AGENDA
La Vergne Planning Commission
February 27, 2024 at 6:00 PM

Item Title: Site Plan - Blair Ridge - 141 Dwelling Units in 26 Buildings. Requested by SEC, Inc. Property located on Blair Road (Tax Map 29, Parcel 21.01). R-3 (High Density Residential) Zoning District. Property owned by 303B Partners. DEFERRED

Summary: On behalf of their client, SEC is requesting approval of the site plan for Blair Ridge, a townhome community.

REVISED:					Preliminary Plat
DRAWN: SJA/CFB3					
DATE: 12-29-2023					
CHECKED:					
MAT.					
FILE NAME:					
19258phase1					
SCALE:					
1" = 30'					
JOB NO.					
19258					
SHEET:					C1.6

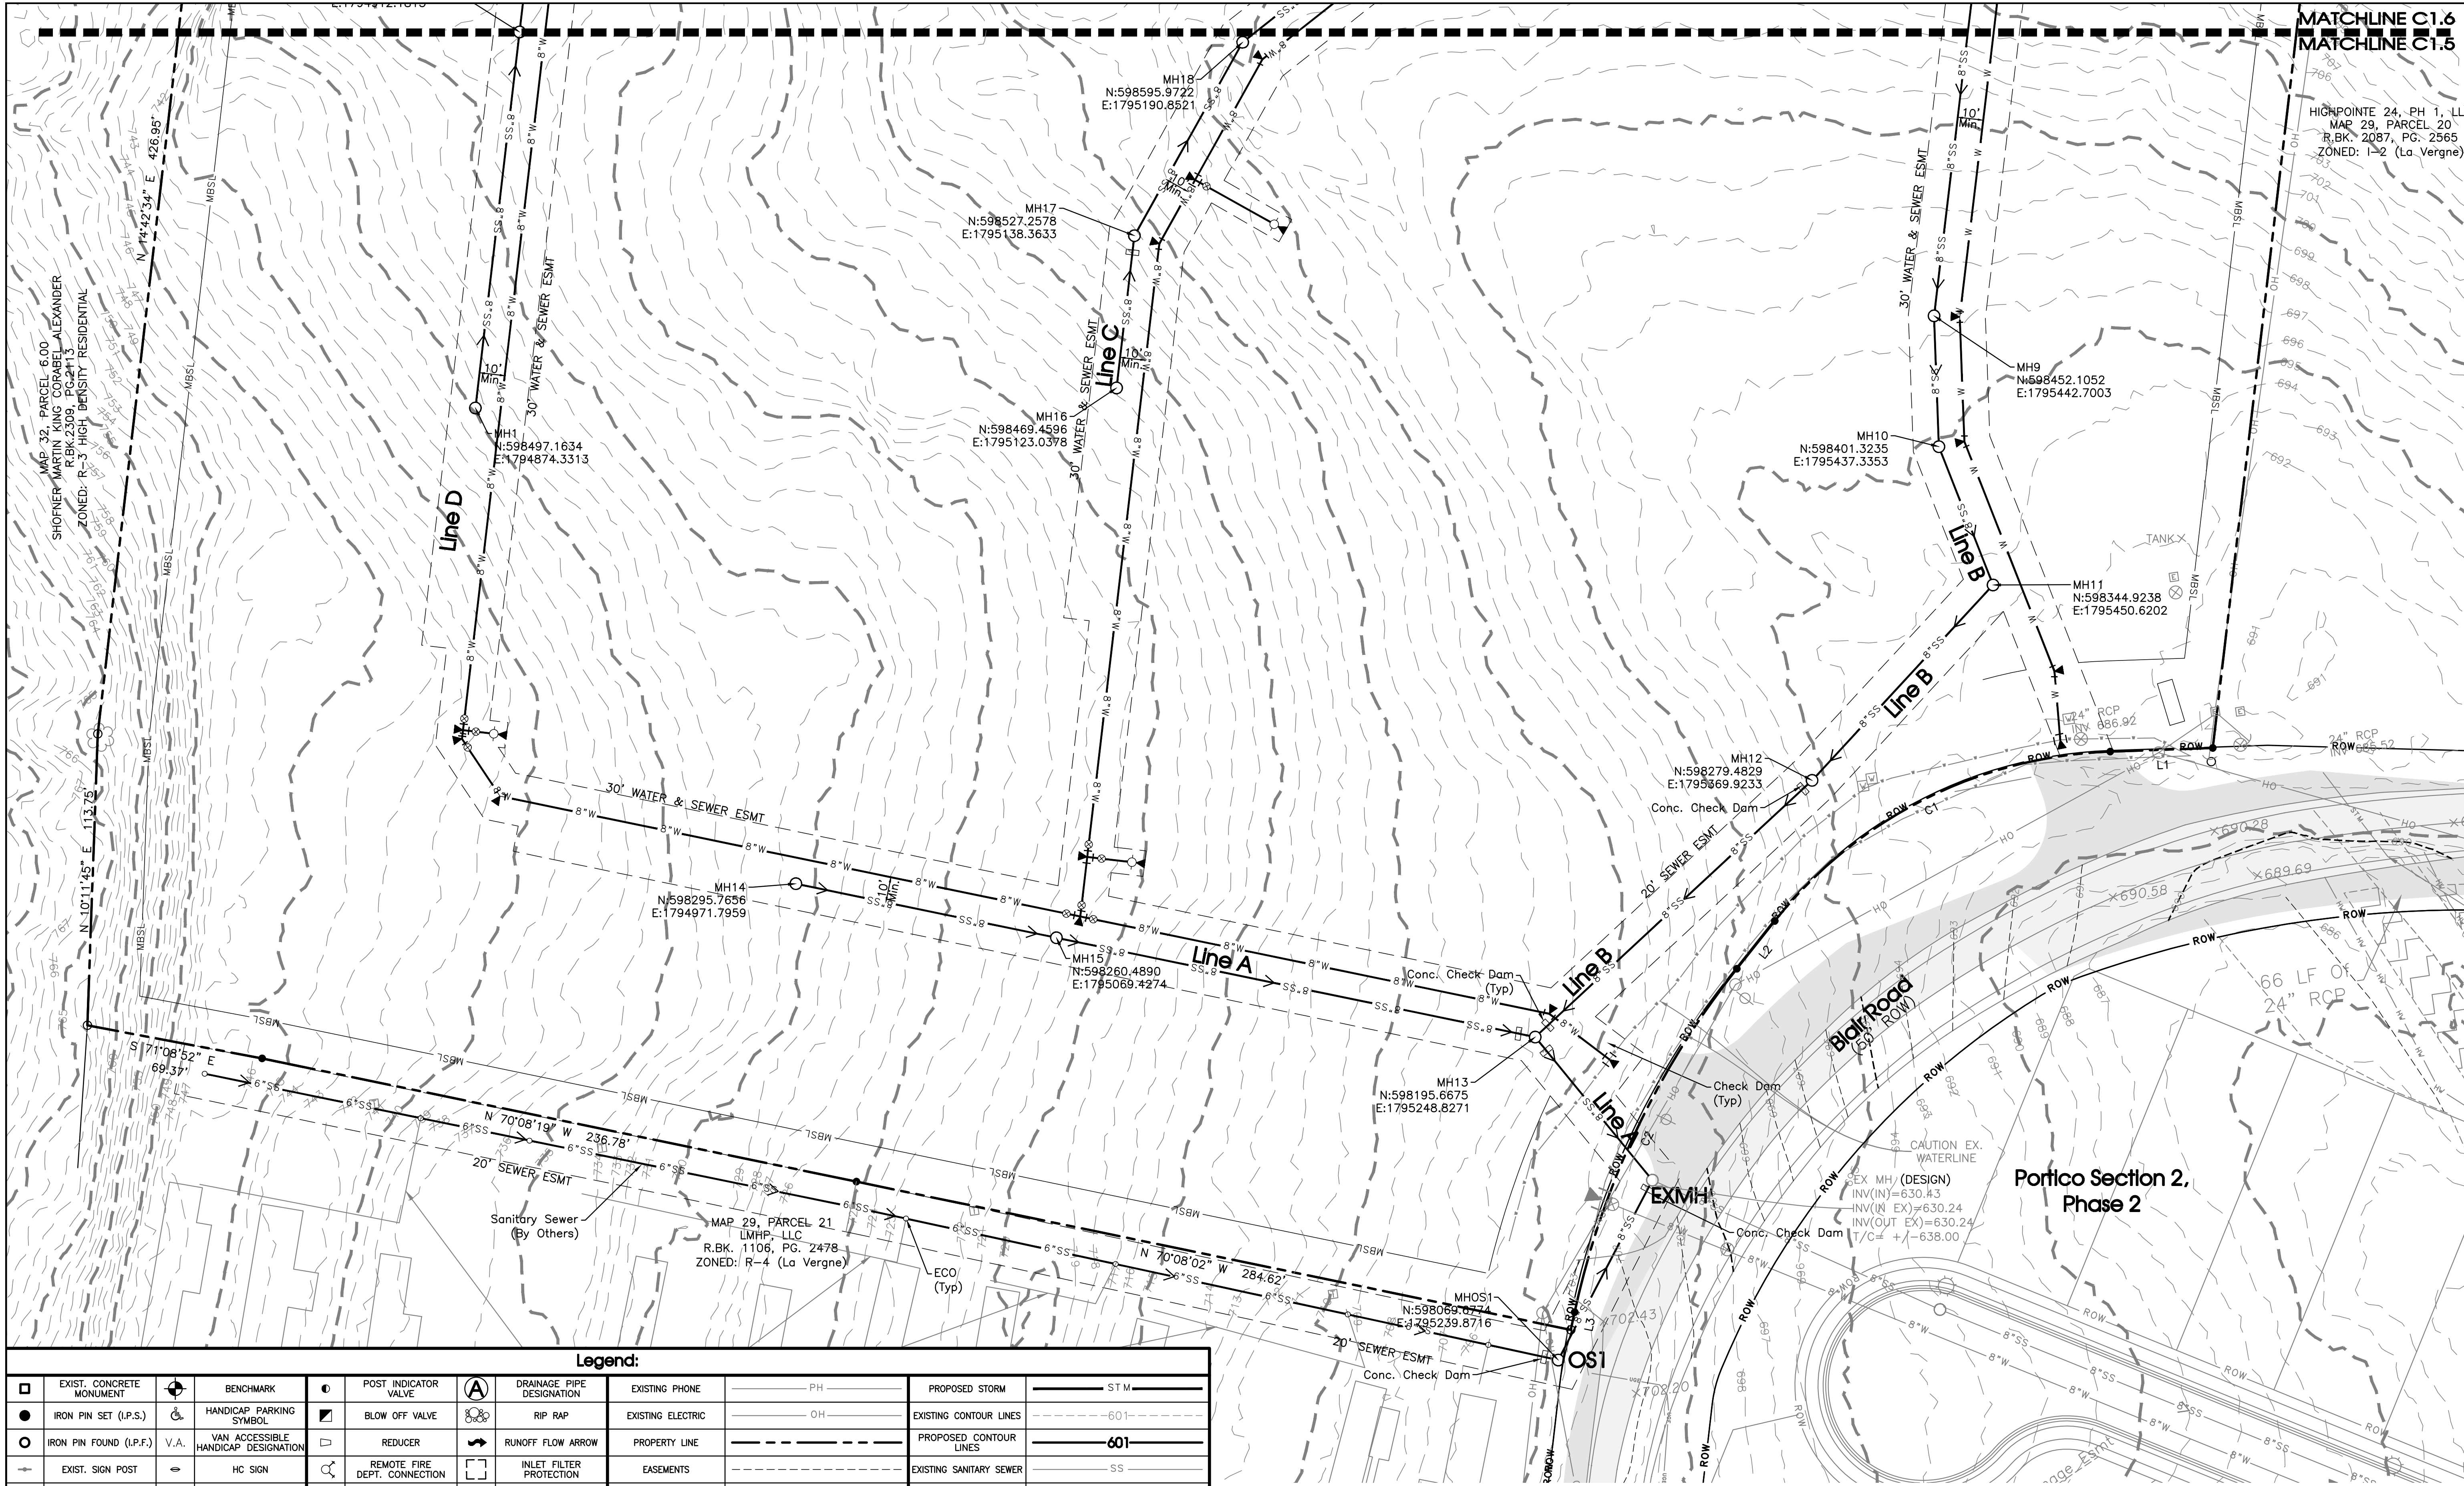
The preliminary plat must be a stand-alone document without need for being cross-referenced to the Site Plan.
1. Provide a location map.

2. Provide boundary data for Blair Road ROW margin.
3. Add note about floodplain limits
4. Provide name and address of property owner
5. Please provide a copy of the Title Commitment (specifically comment 3-3) which describes the agreement between the Blair Ridge property owner and LMHP, LLC to the south regarding sewer service for the LMHP, LLC parcel.

6. Since this project will be taking away all or a portion of the septic drain field for the LMHP property to the south, the statement that the proposed sewer line which will provide service to LMHP, LLC will be "By Others" is questionable. Please provide a coordinated plan with LMHP, LLC confirming that they understand the scope of the work required by them and the agreed schedule for that work.

5. Given that the sewer easement on the LMHP, LLC property is required for the work shown on this preliminary plat to take place, please provide the document which will be used to record that easement.

5. Show Zoning Classification.
6. Show map and parcel number for the lot.
7. Show location of retaining walls
8. Show location of any proposed signs (not including traffic signs)

Waterline Plan

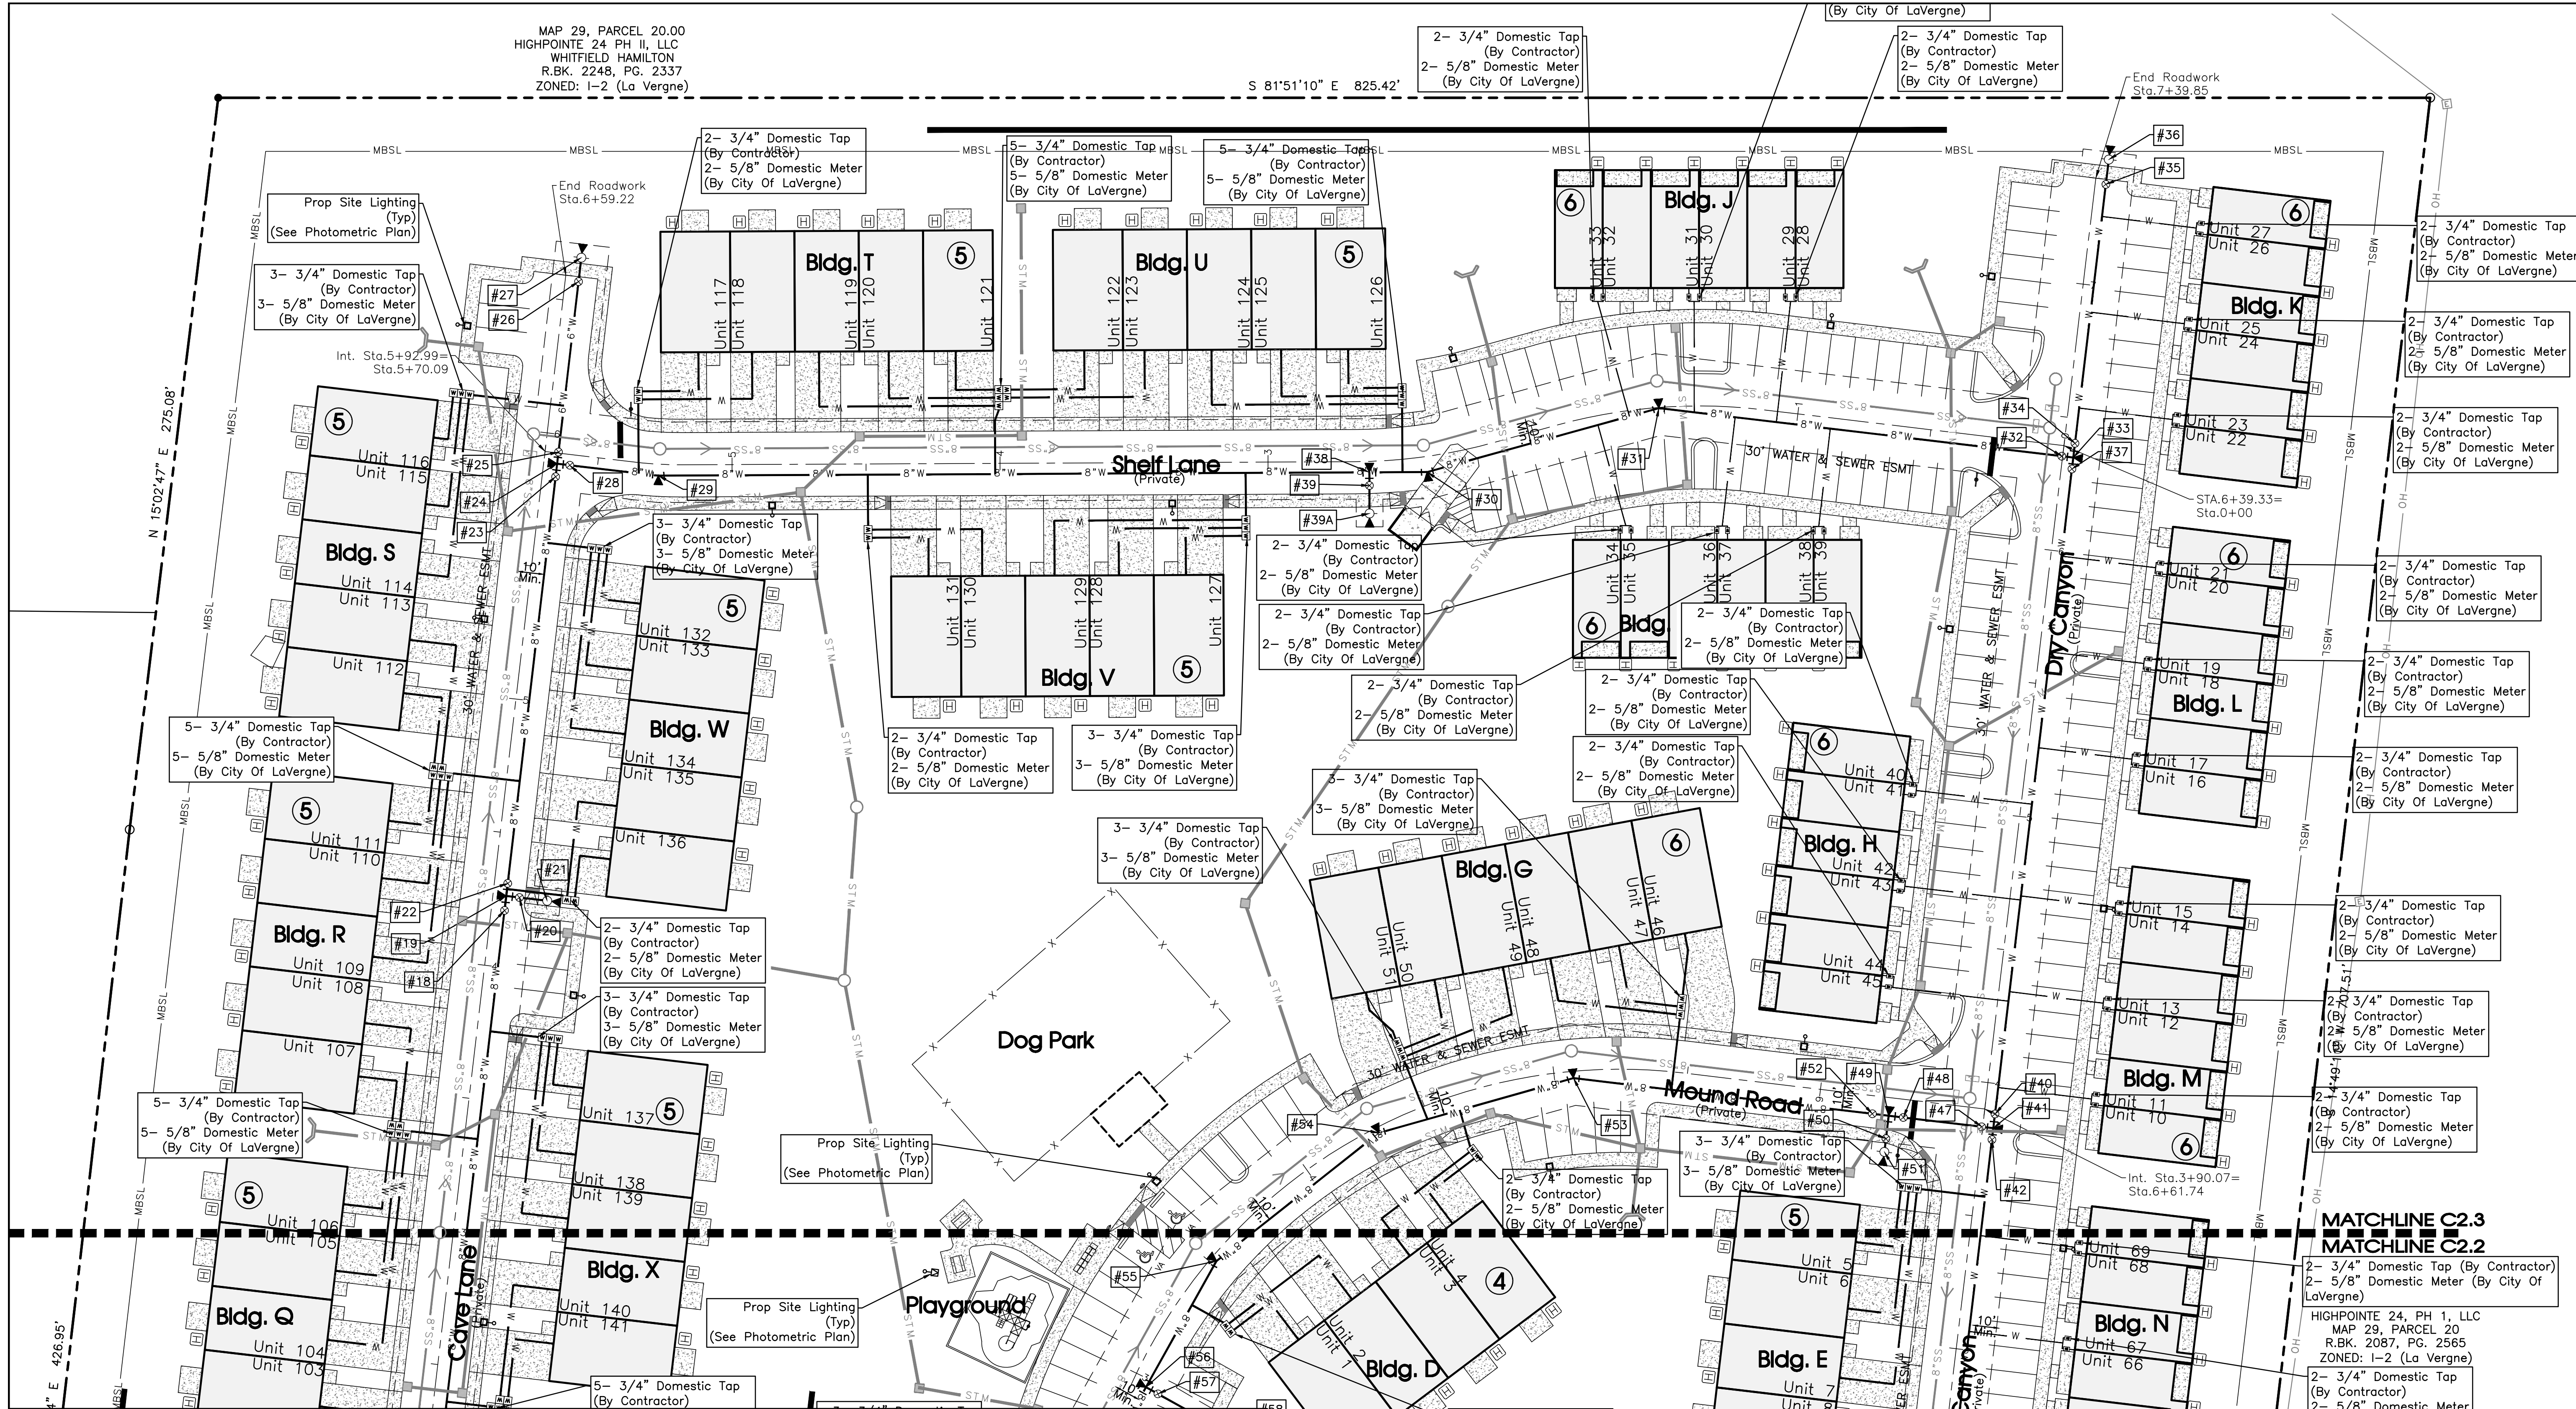
5. Sht C2.3: Add FH, near sec of building U on Shelf Ln., current spacing is greater than 500 feet.
6. Sht C2.3: Move FH (item#39) on Dry Canyon to end of line (north of current location), and remove blow off assembly at end of line.
